**City Council November 5, 2019 Public Hearing**

**Marketplace Final Development Plan - Parcel B (Office and Garage)**

***Appellant:***            ***Wareham Development***

Marketplace Parcel B Appeal

## WIND:

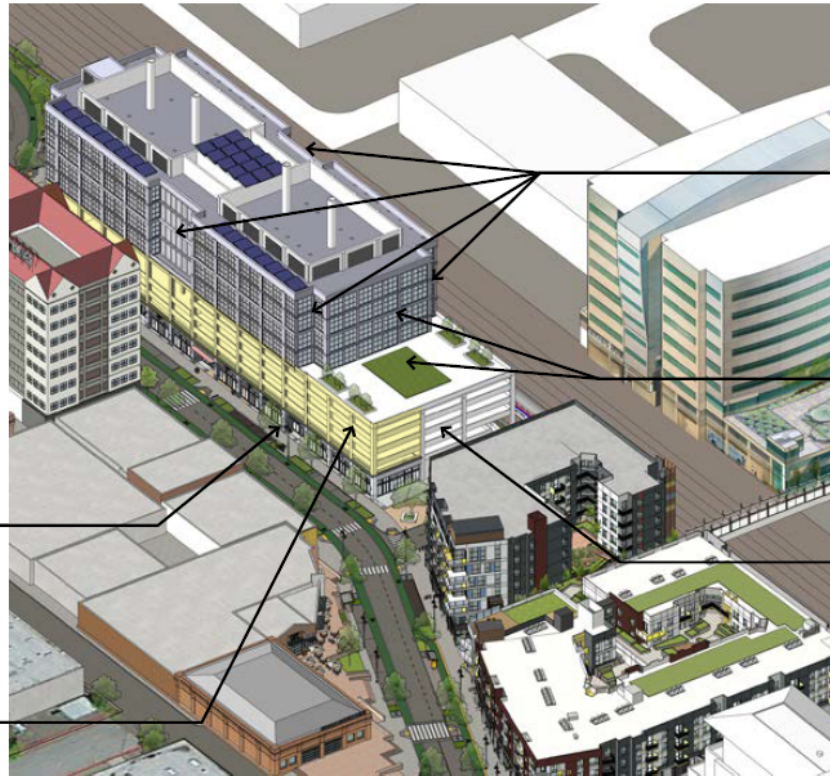
**CONCERN:** WE'VE HEARD CONCERNS ABOUT WINDY CONDITIONS AND WIND COMFORT ALONG SHELLMOUND STREET.

**RESPONSE:** THE OPEN-AIR PARKING GARAGE FORMING THE PROJECT'S "BASE" PROVIDES A BETTER RESPONSE TO WIND THAN THE SOLID BASE OF THE ORIGINAL P.D.P. (REFER TO THE WIND REPORT FOR DETAILS). STREET TREES ADD ADDITIONAL BUFFERING OF WIND TO ENHANCE WIND COMFORT.

## PARKING:

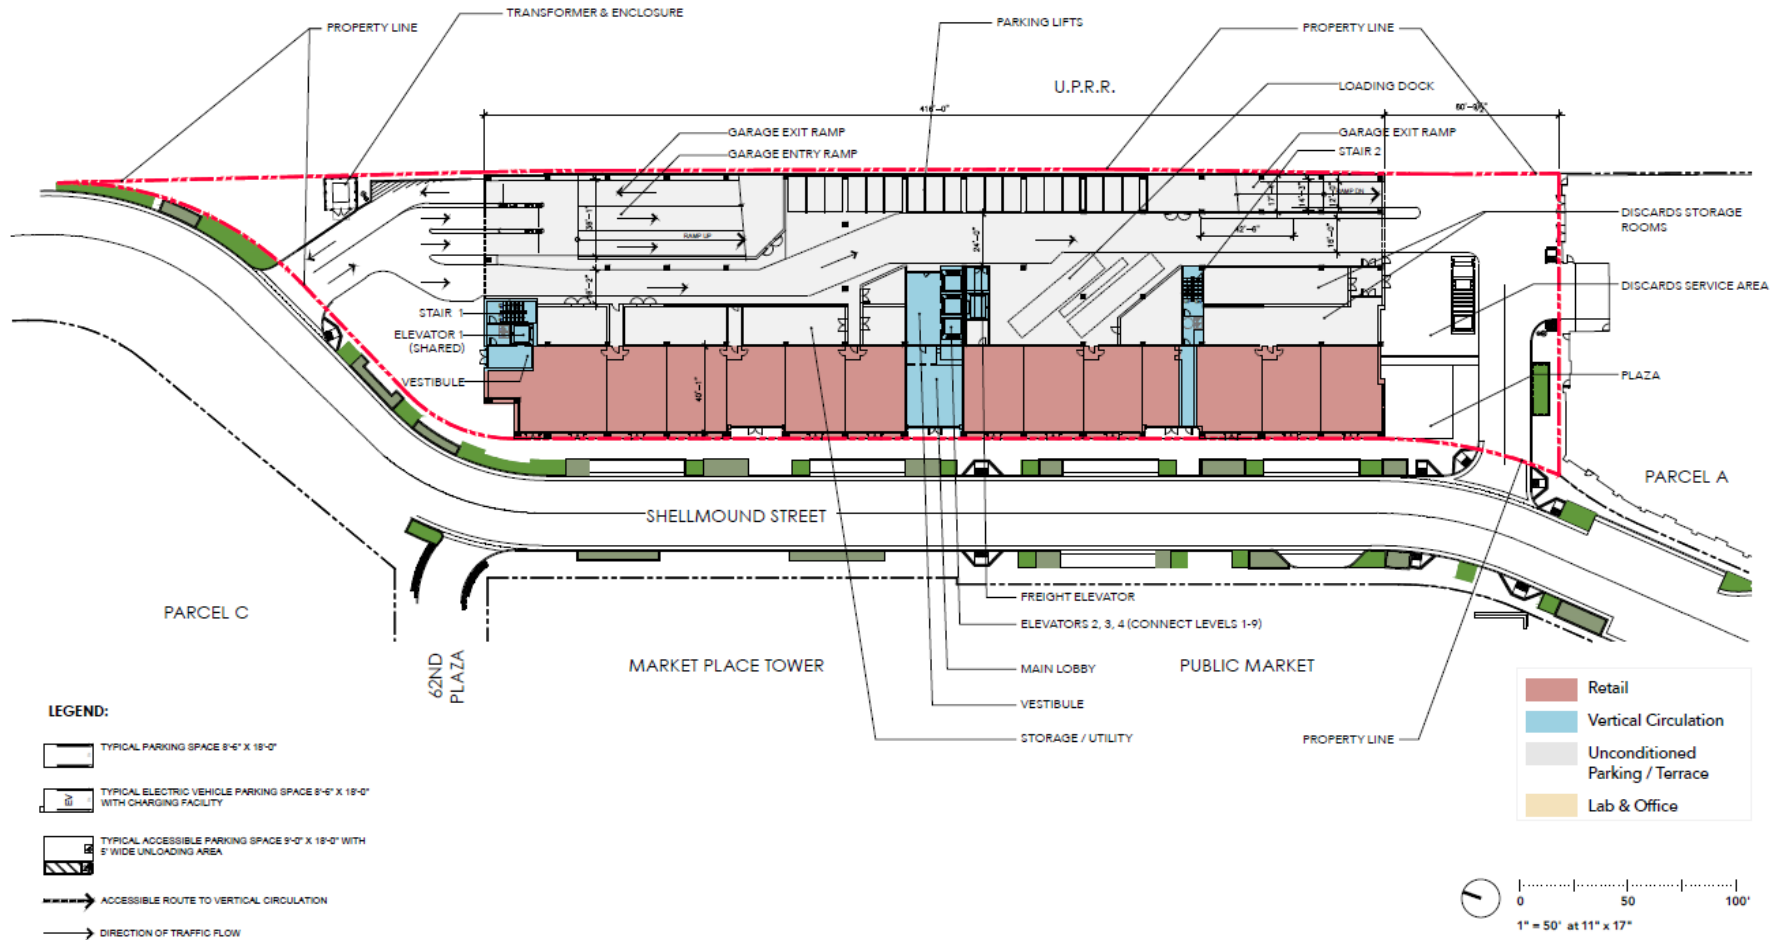
**CONCERN:** WE'VE HEARD THAT WE SHOULD AVOID THE OVER-PROVISION OF PARKING TO REINFORCE TRANSIT.

**RESPONSE:** WE'VE CUT BACK THE SIZE AND CAPACITY OF THE PARKING STRUCTURE BY 10%, WIDENING THE GAP AT THE BASE COMPARED TO THE APPROVED JANUARY F.D.P.

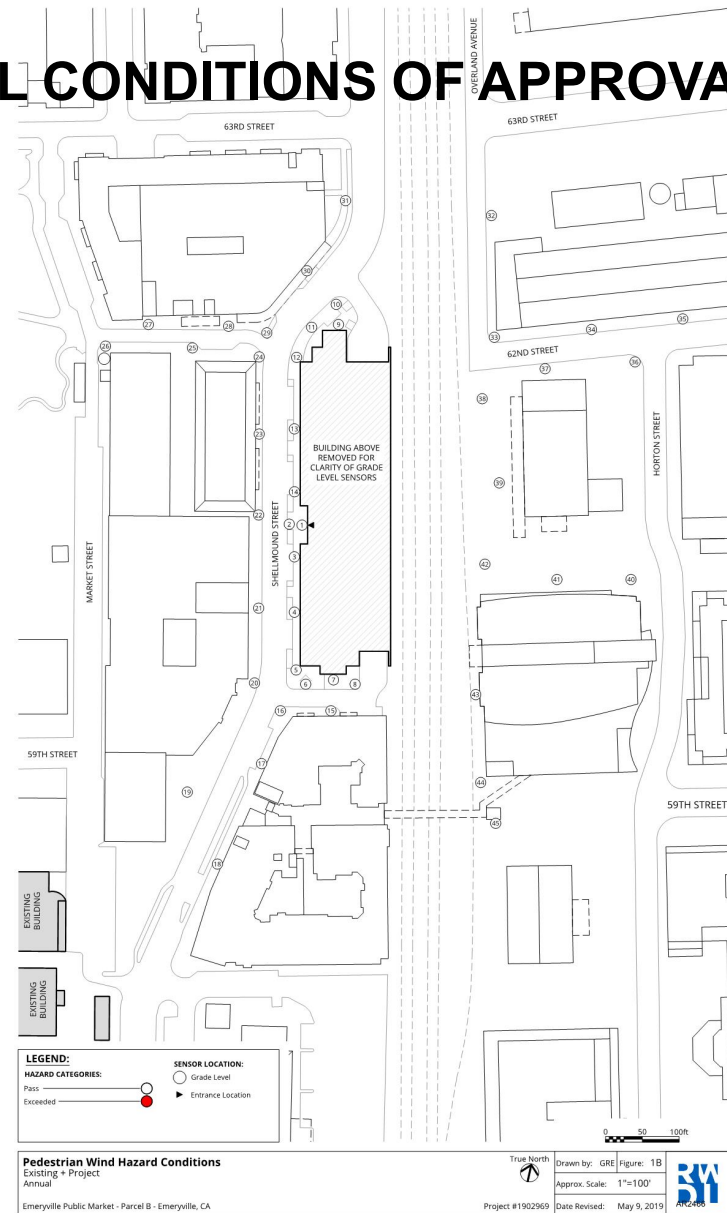
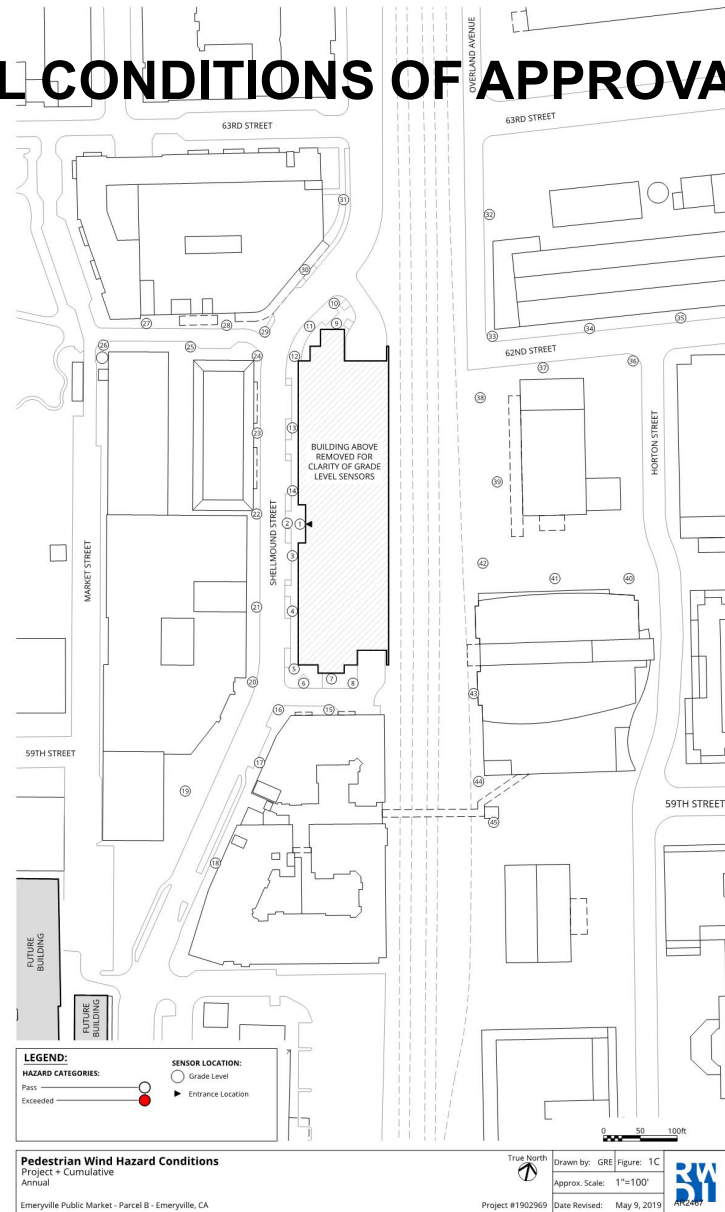
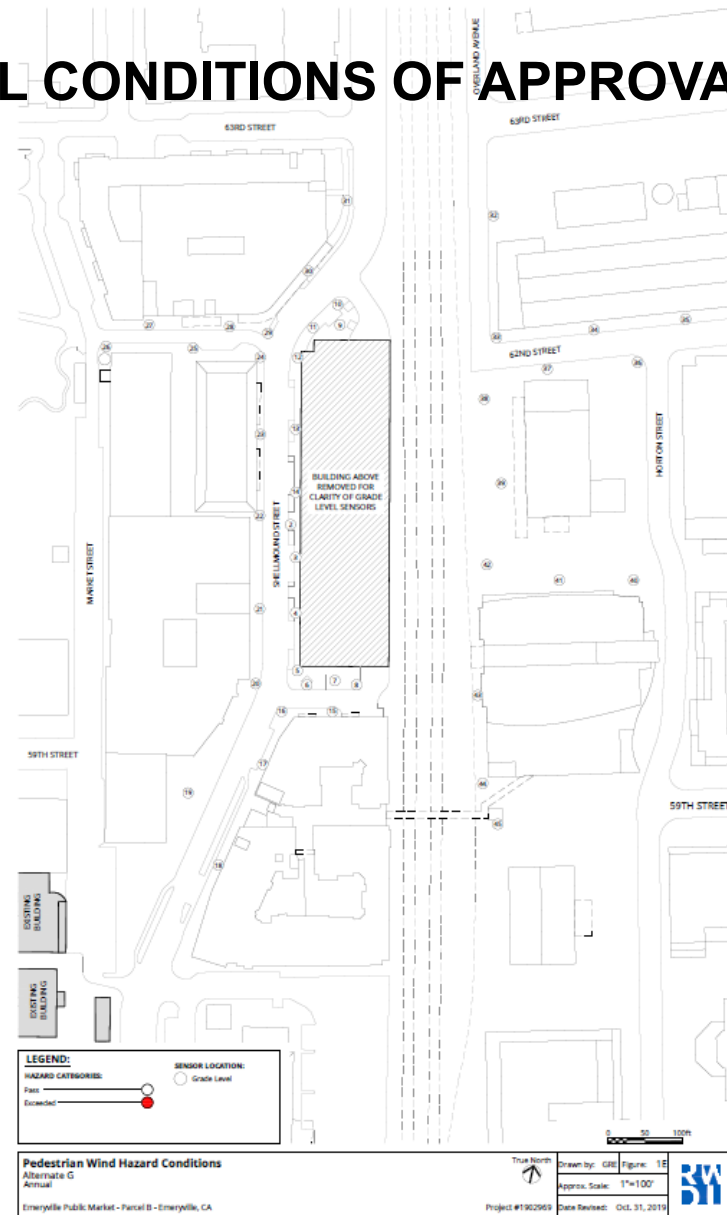
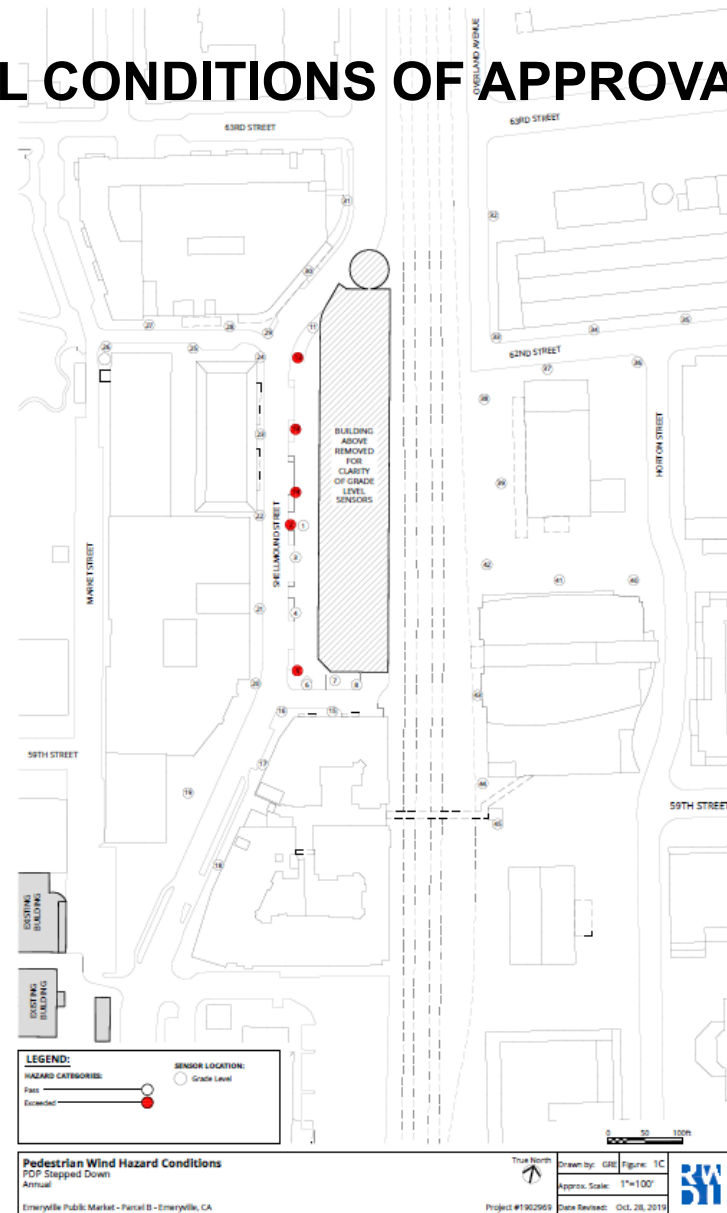
- The Project does not result in winds exceeding 36 mph, and therefore complies with conditions of approval related to wind.
- Conditions of approval do not specify a wind speed threshold for wind comfort. Project will result in pedestrian wind comfort conditions similar to existing conditions.
- Applicant's Proposed Alternative would result in similar wind conditions to the Project, and likewise would comply with conditions of approval related to wind.

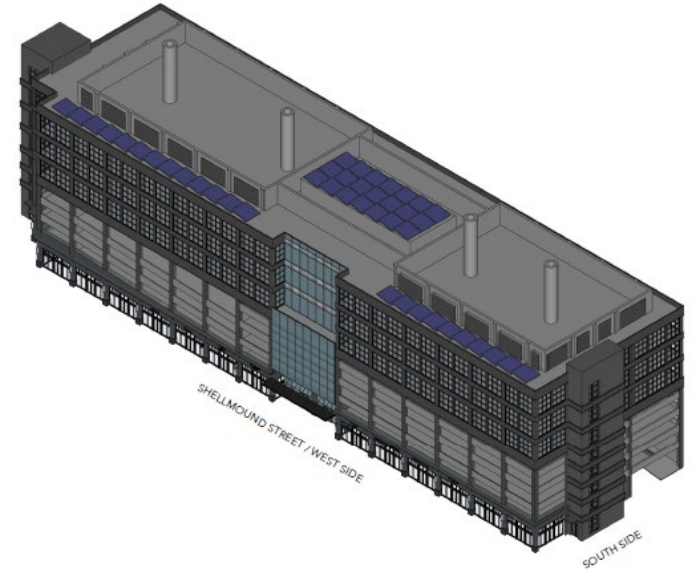
“Proposed structures shall adequately reference and be visually compatible with **surrounding industrial buildings.**”

The only surrounding industrial building is the existing Public Market building, a 1-2 story masonry industrial adaptive re-use project that sets a precedent for the type of reference that is appropriate for the area. The Project’s “smoke stack” features and divided glass and metal window system are signature industrial type design that reference the surrounding industrial buildings.

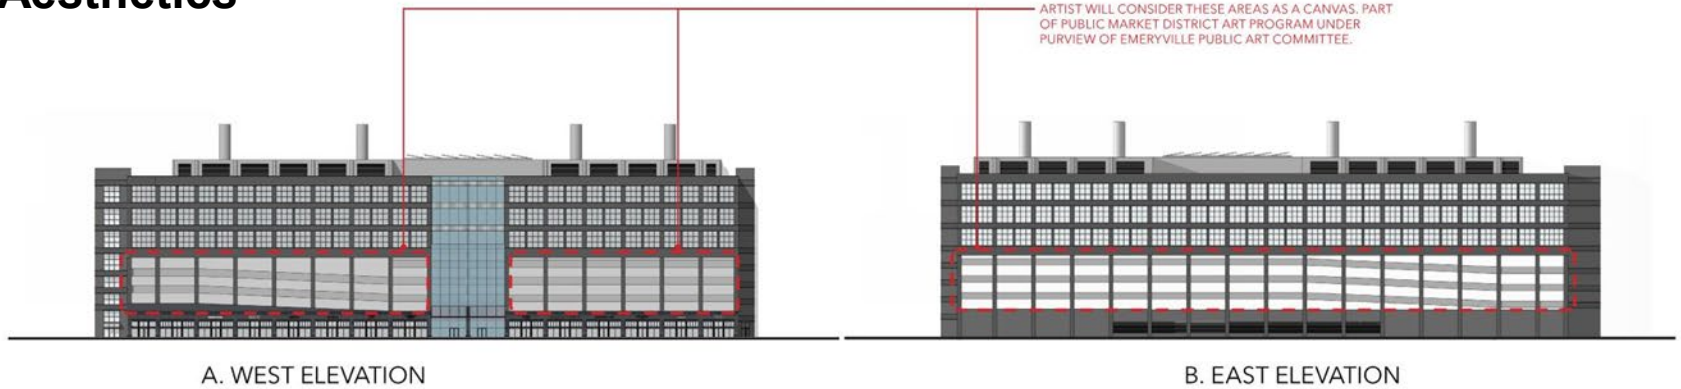
“All proposed new buildings shall be shown in detail.... Towers and buildings along the railroad tracks shall be articulated with treatment such as variations in building planes, color and materials, balconies and trellises to **ensure that no visual wall is created along the railroad right of way.**

The Project’s four levels of concrete parking structure will each be articulated by art panels on the east and west elevations. In addition, the Planning Commission conditions of approval require that “the open parking on the north and south elevations shall be screened with an aesthetically pleasing treatment that is compatible with that of the east and west elevations.”

Since the Applicant is proposing to use public art to satisfy a planning condition of approval, the City Council could add a condition of approval to the FDP requiring that the public art to be applied to the building be approved by the City Council prior to issuance of a building permit, to confirm that it adds sufficient articulation to satisfy the requirements of the PUD conditions of approval.

The Applicant’s Proposed Alternative plans include a statement that “the building provides a canvas for public art, and will integrate the winning artists’ concepts, with Council participation, on the east and west sides of the ‘base’.” [emphasis added]

## Height

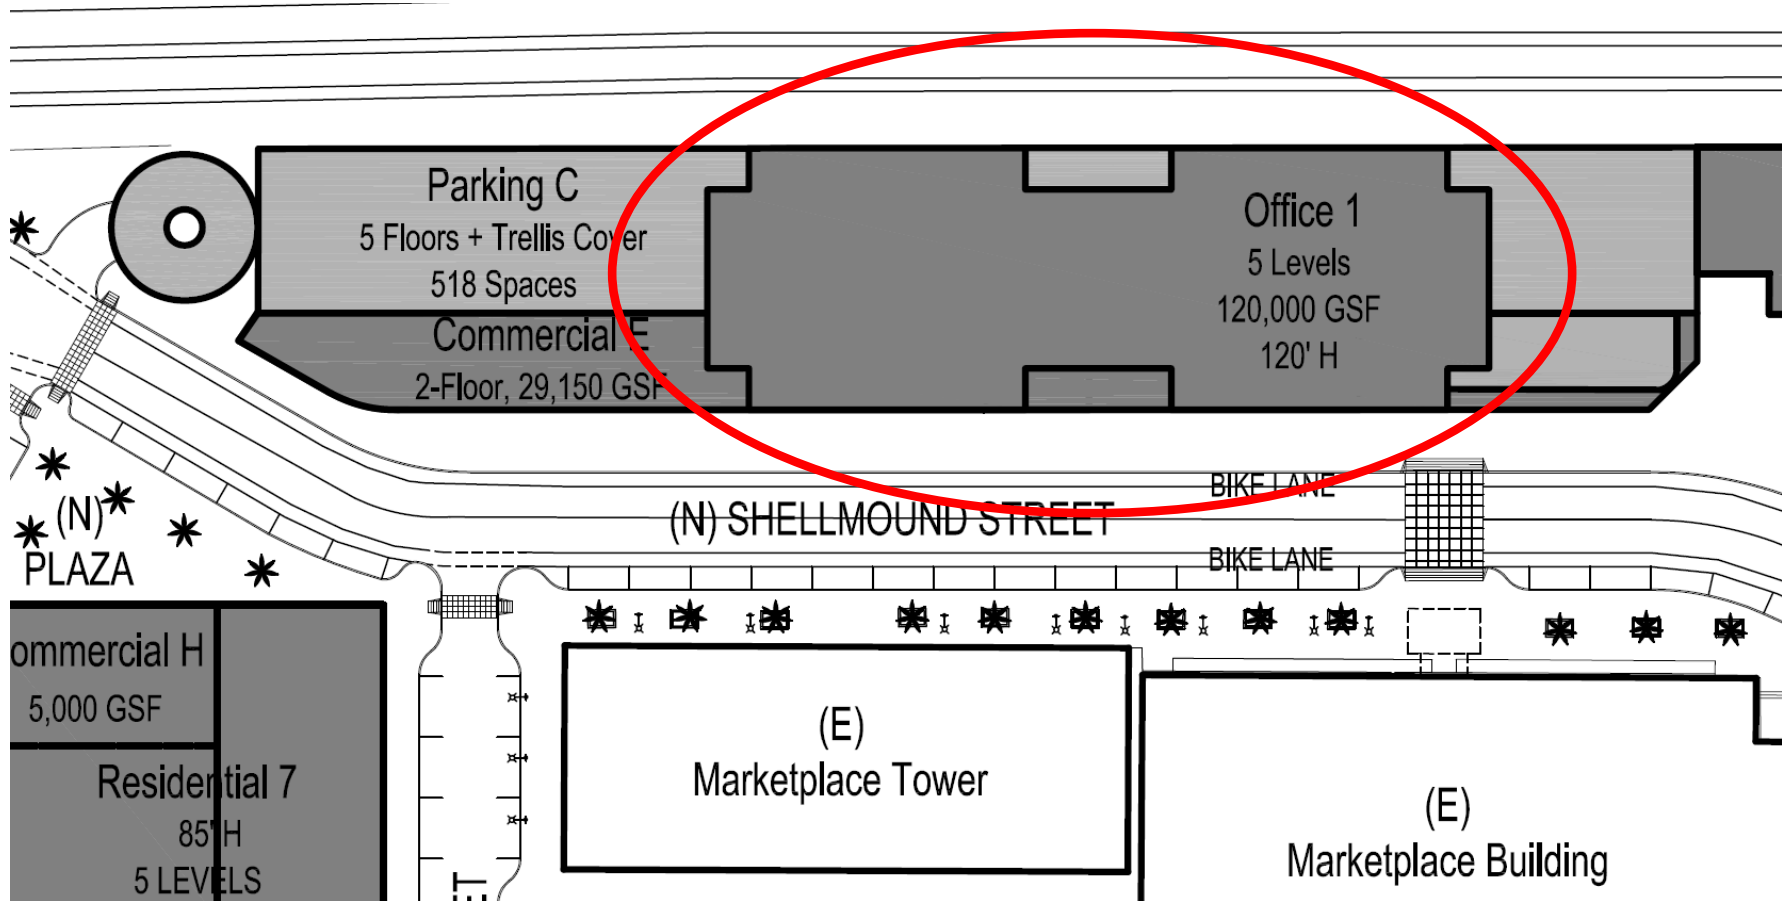
- Conditions of approval specify height of various sites, but do not specify how much of each site are subject to various heights.
- For site now known as Parcel B, conditions of approval say only “Height: Maximum height not to exceed 120 feet.”
- Diagrams in PDP that indicate building heights are illustrative, not to be taken literally regarding building footprints.
